City of Sedona Public Works Department

The City of Sedona, Arizona is issuing **Addendum #2** to the plans and specifications as originally issued at the time of solicitation for bids for the re-bid of **SR 179 Pedestrian Crossing at Oak Creek**. For any bid to be considered responsible and responsive, receipt of this addendum must be acknowledged.

This Addendum further extends the bid period beyond the extension issued under Addendum 1, providing a new date for which sealed bids must be submitted; responds to questions related to the project plans and specifications; and provides for revisions made to the project specifications and drawings.

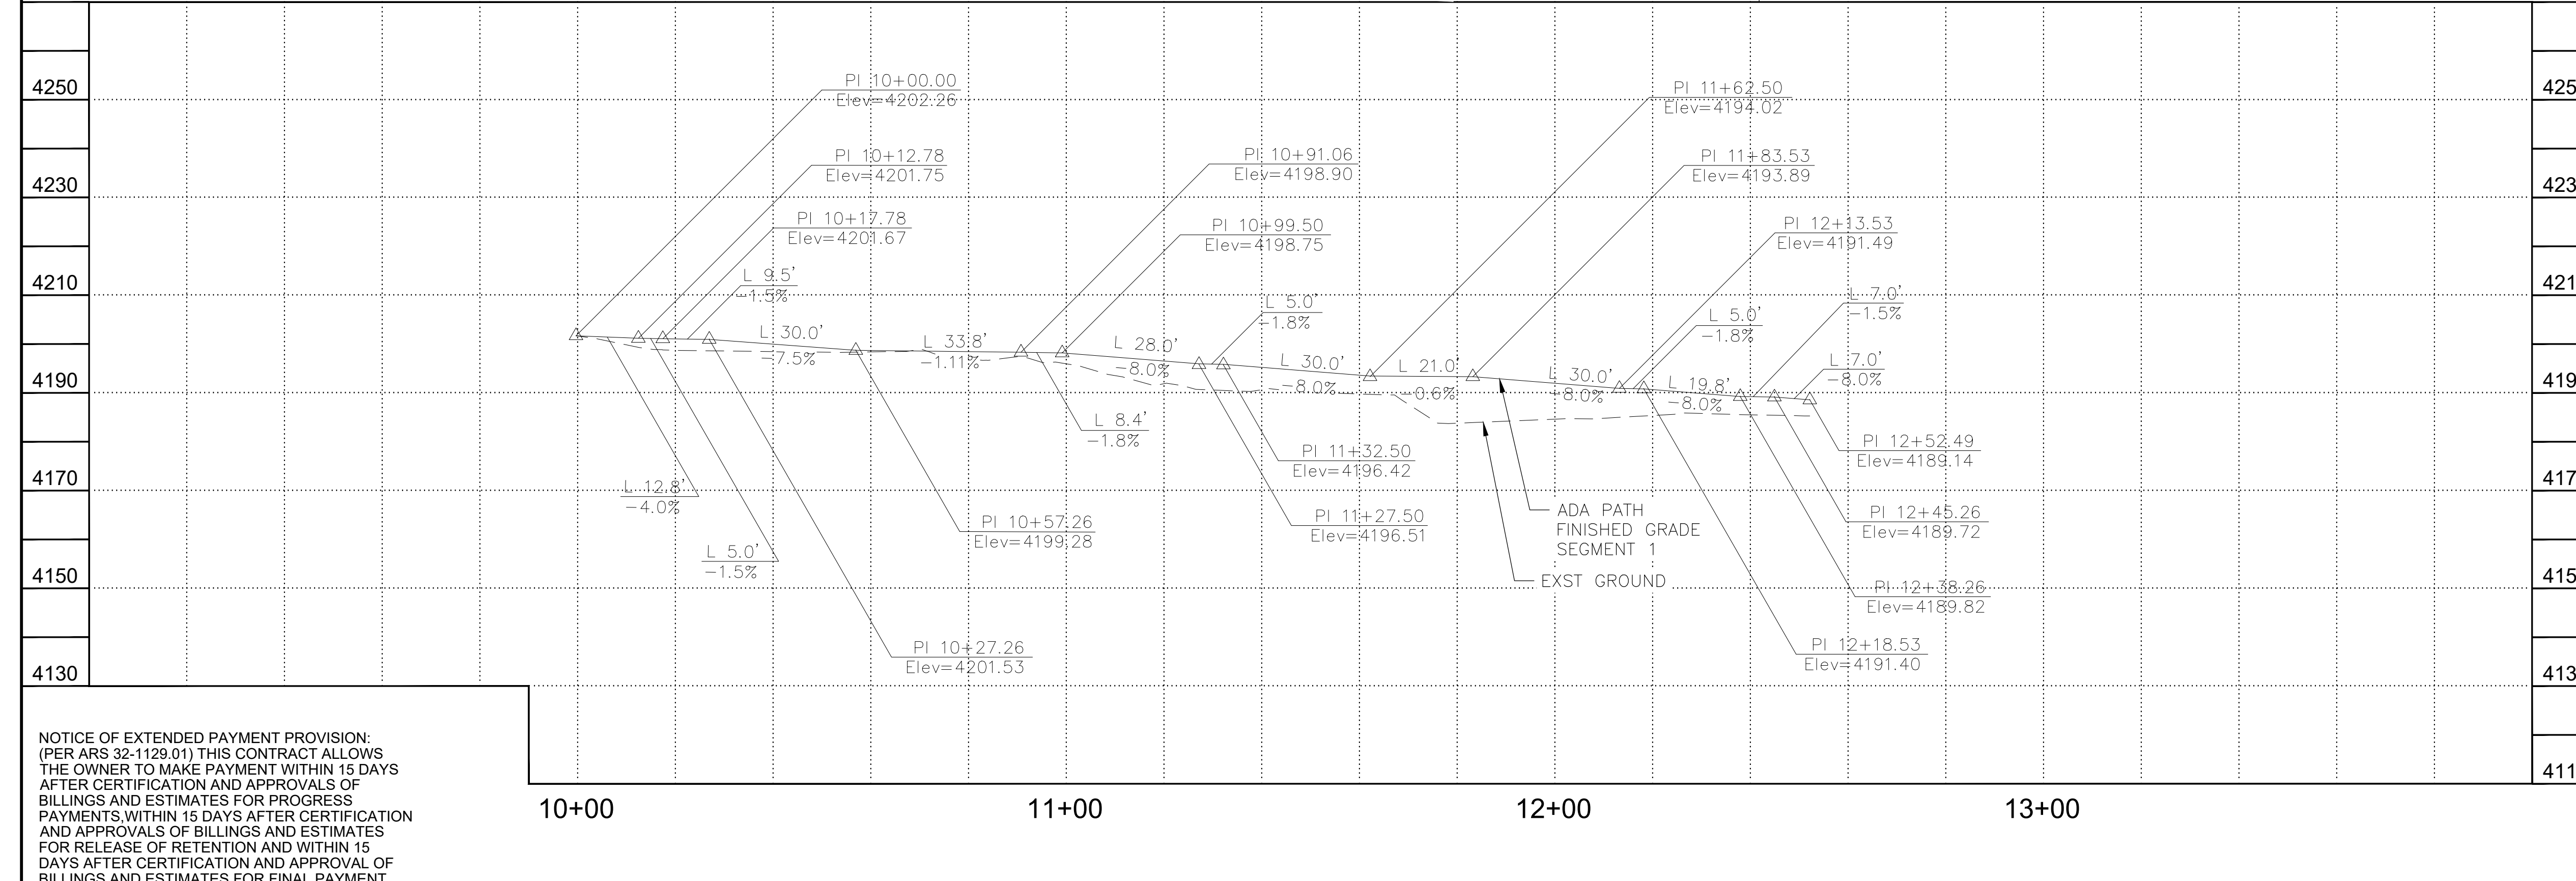
3.3. **Question** – The Bid Item 2.2.15 "Relocate Water Meter" and 2.2.16 "Relocate Existing Light Pole" do not have any associated construction note in the plan sheets. Can the location of these be provided?

6.3. Replace plan sheet number 7 of 45 (C7), with the following:

Construction Notes 14 and 15 were added.

Response – Design will provide a construction note on Sheet 7 – C7
